Technical Service Bulletin

AUTOMOTIVE <> PASSENGER CAR ACCESSORY BELT DRIVE SYSTEM

BULLETIN PA010-12

ACCESSORY BELT DRIVE SYSTEM

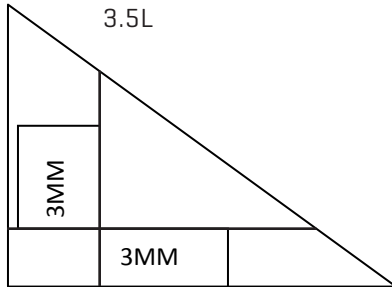
Particular V-6 applications described in Honda Bulletin 08-082 may require a small modification to the front timing cover during replacement of the accessory drive belt tensioner. [Gates part number 38332] The OE now provides an updated tensioner assembly which may cause interference with the front timing cover of some applications. Gates also offers the same, updated design as the OES. The small task is to remove approximately 3mm of plastic material from the front cover, allowing proper clearance.

This area will need to have 3mm of material removed.
